*PLANS FOR THE CONSTRUCTION OF
SEDIMENT REMOVAL
FOR
VITRUVIAN PARK
TOWN OF ADDISON, TEXAS
PUBLIC WORKS #19-77*

VITRUVIAN PARK
 DREDGING
 TOWN OF ADDISON
 DALLAS COUNTY, TEXAS

revisions	date
1 ADDENDUM 3	2/20/2019

MAIN CHANNEL CROSS SECTIONS				
design	drawn	checked	scale	date
NDM	NDM	NDM	NDM	2/20/19

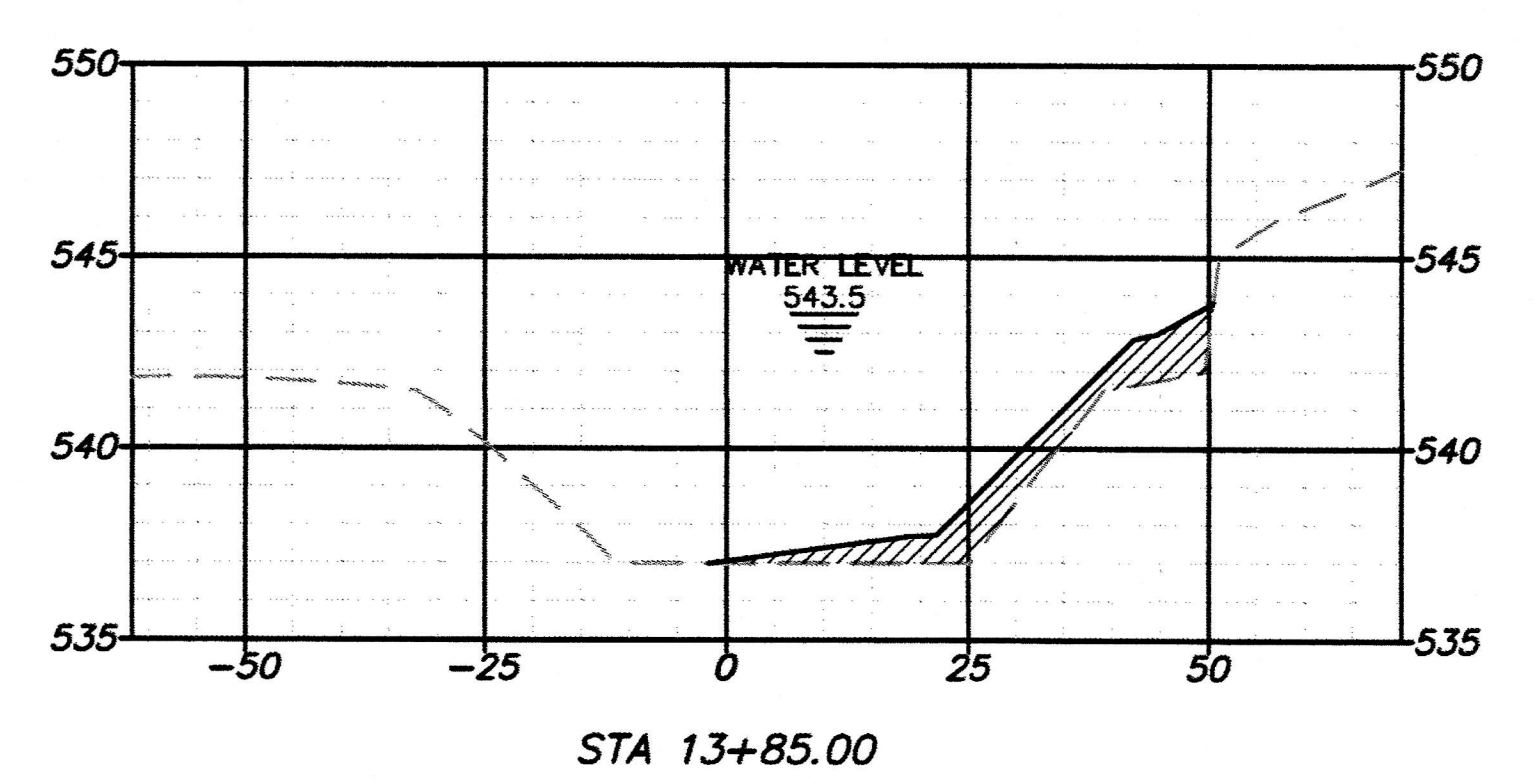
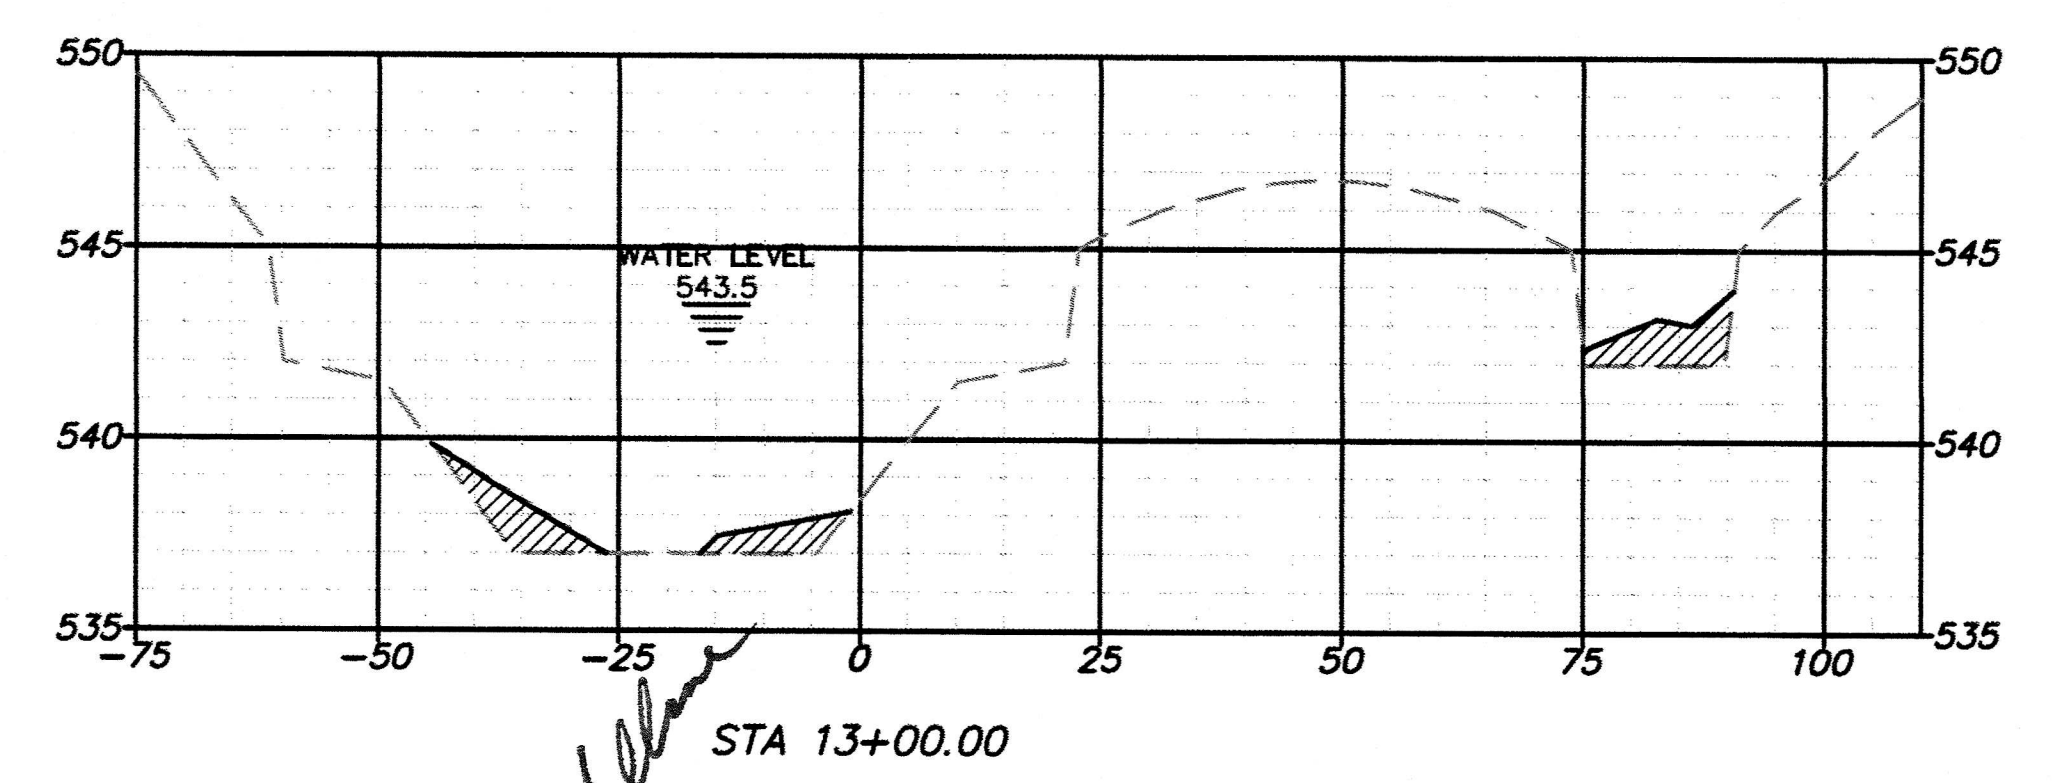
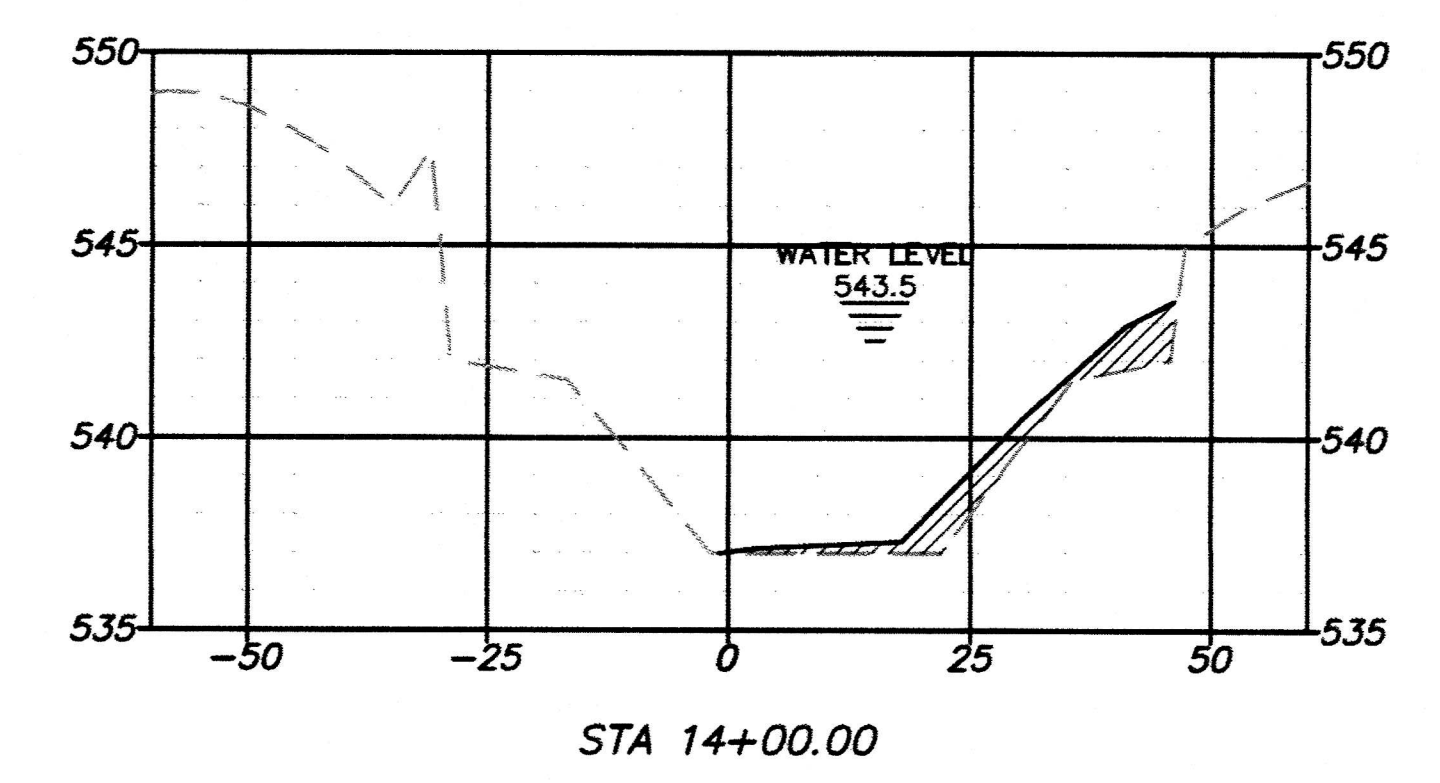
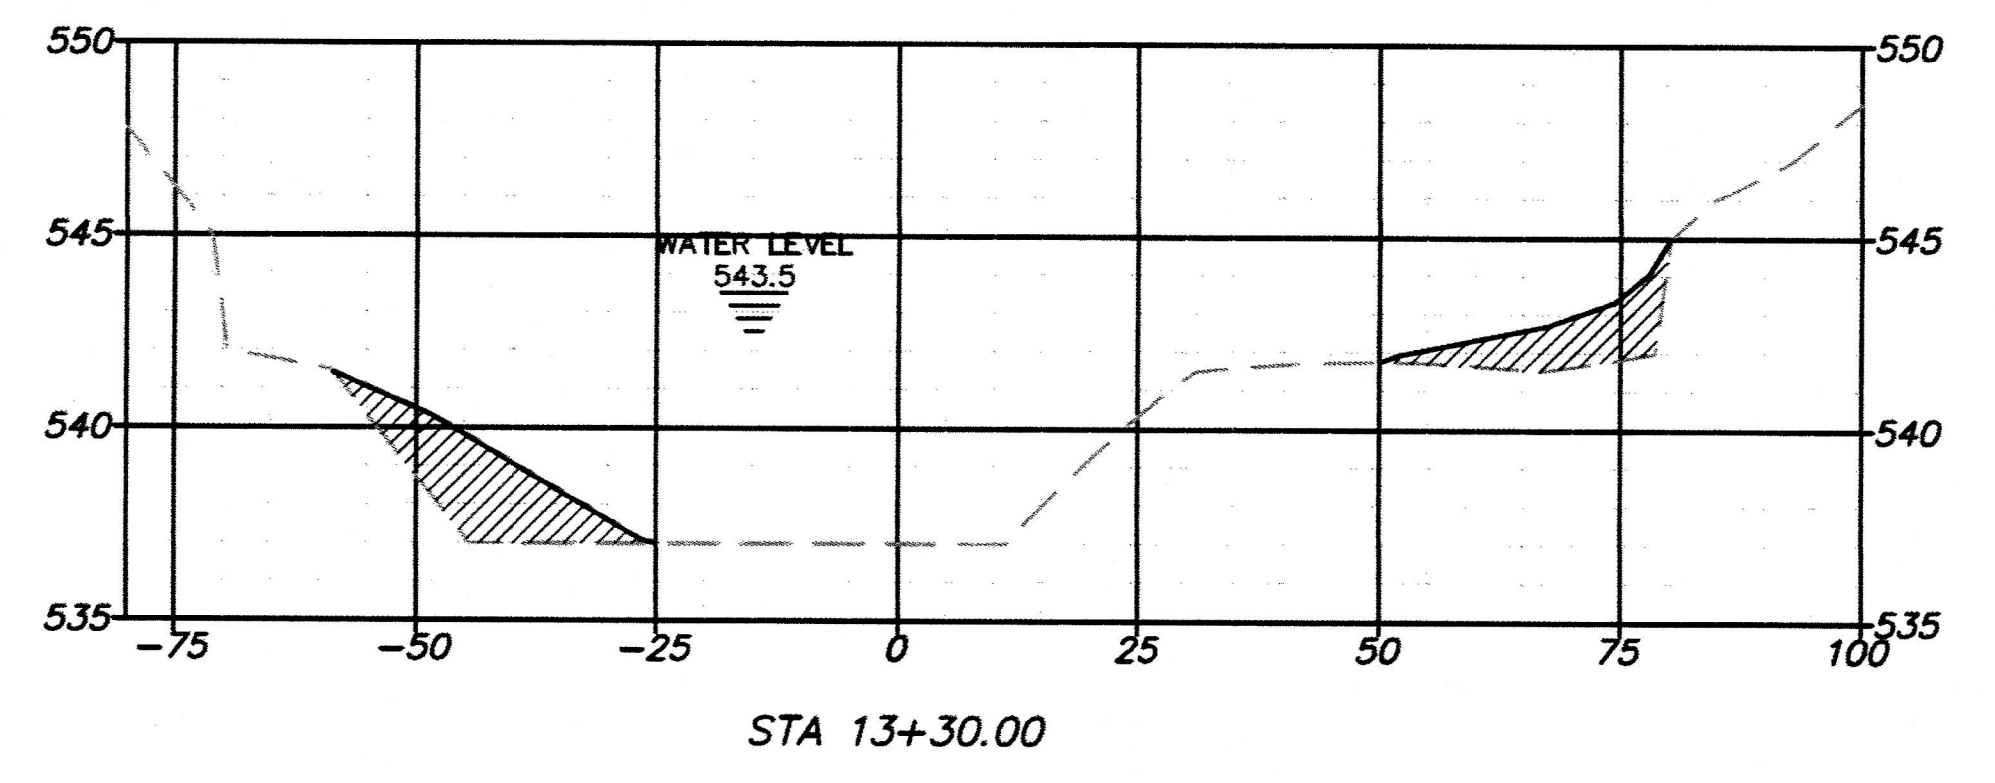
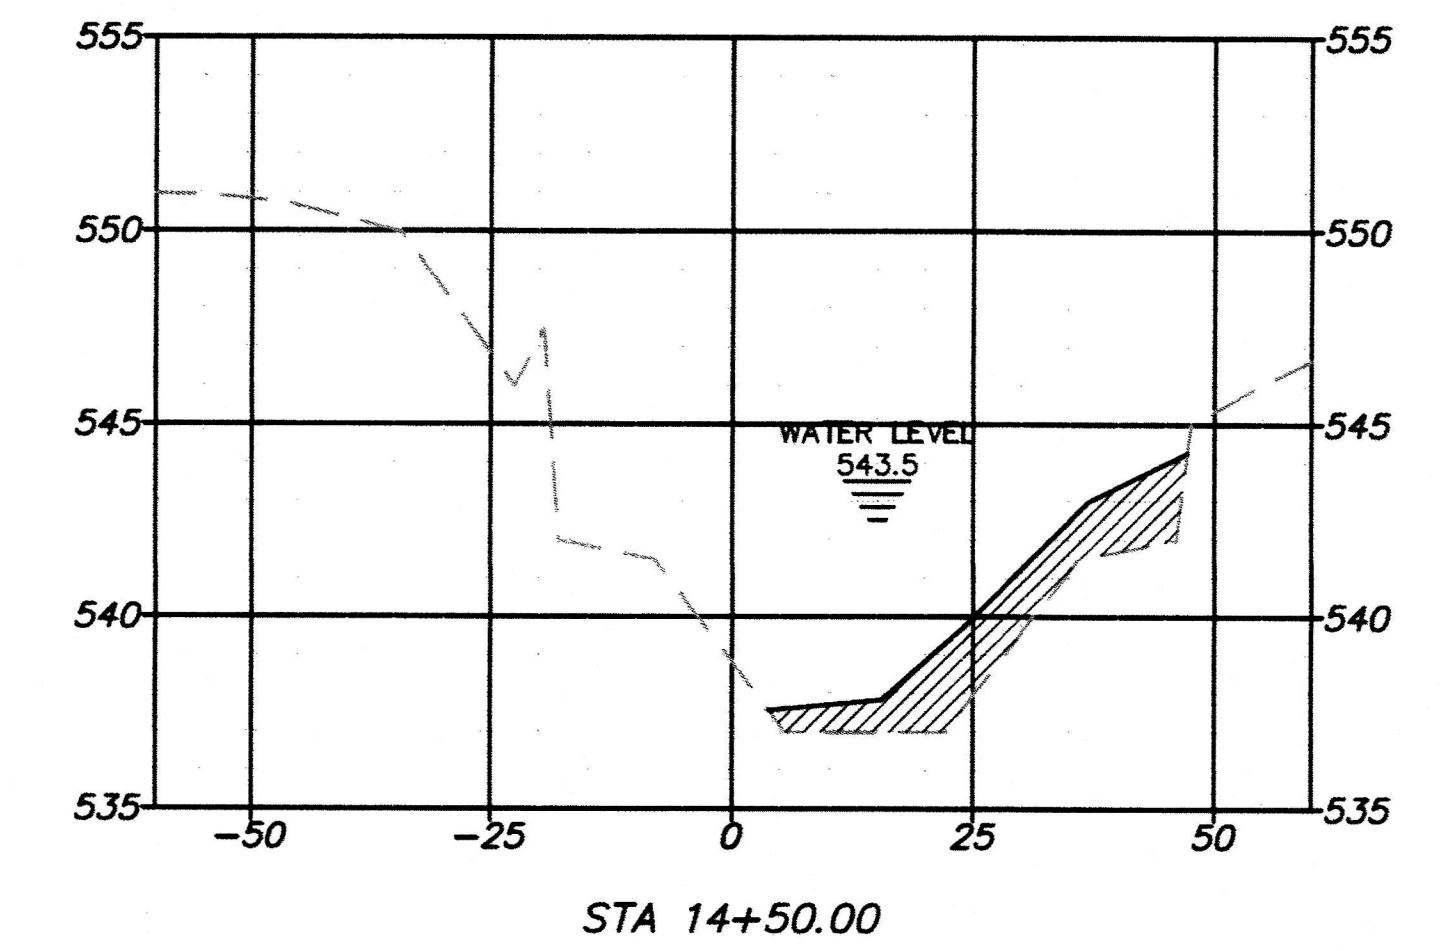
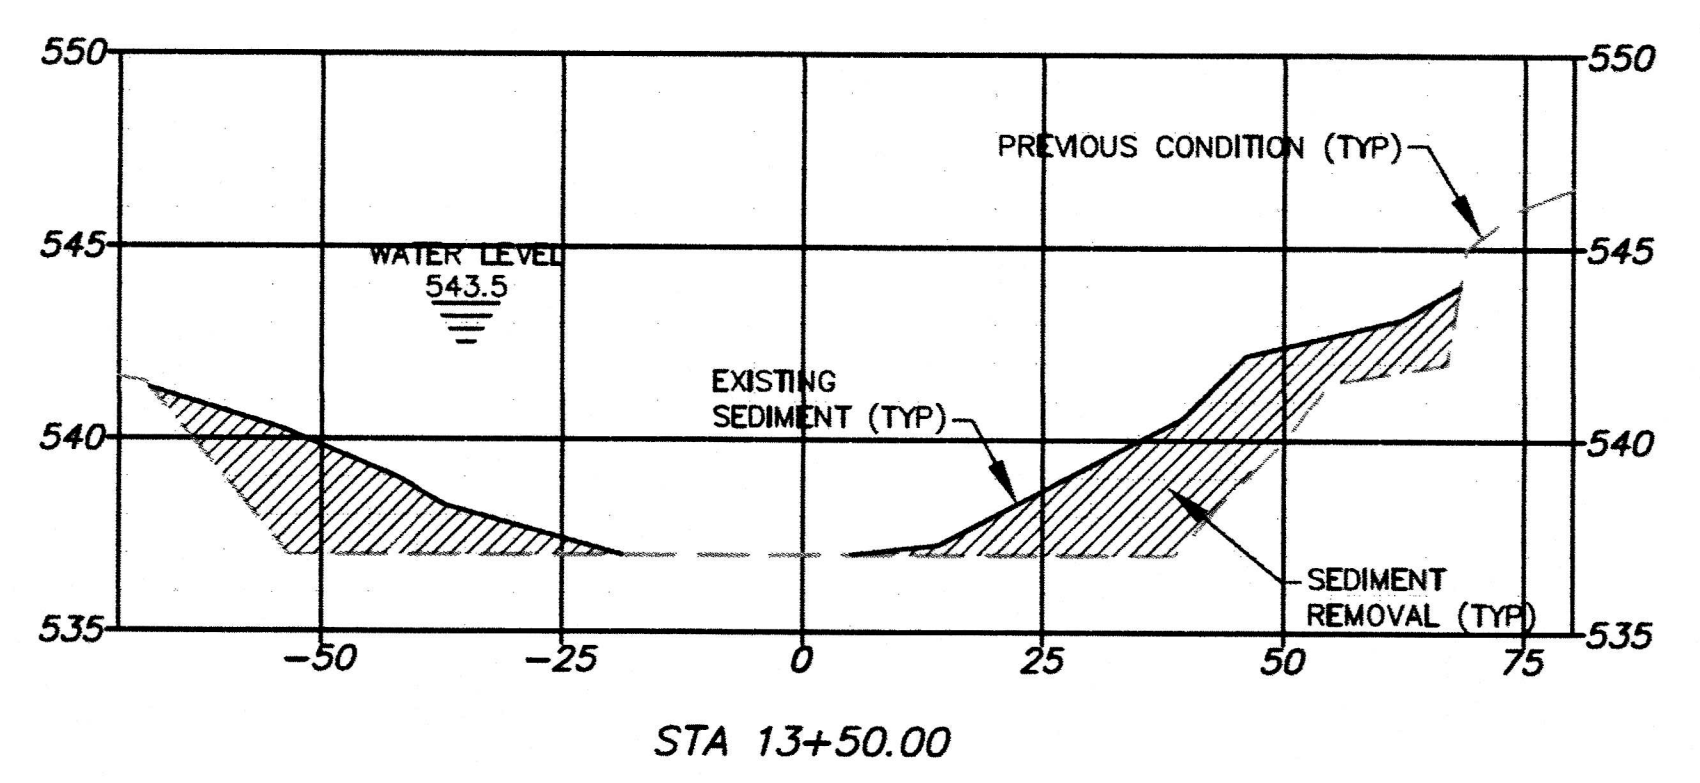
▲ WATER SURFACE ADDED BASED ON SURVEY OF 2/18/2019.
